# Wyandotte Creek GSA Advisory Committee Meeting

# WYANDOTTE CREEK GSA ADVISORY COMMITTEE (WAC) MEETING (7/1/2021)

Minimum Threshold, Measurable Objective, Interim Milestones, and Representative Monitoring Network:

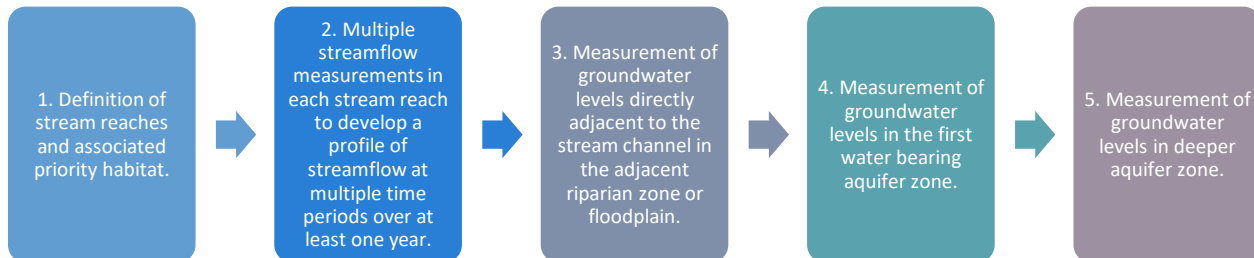
- D. Kehn observed the MO is generally below existing conditions and wondered if that would be an indicator of sustainability. C. Buck (Butte County) shared the MO was set in a way that recognizes the slight downward trend in some wells to give enough time to address the trend.
- Only two wells are currently shown in the Oroville Management Area in the map. The Management Committee will revise the map.

**Recommendation:** Recommend as originally presented in table above.
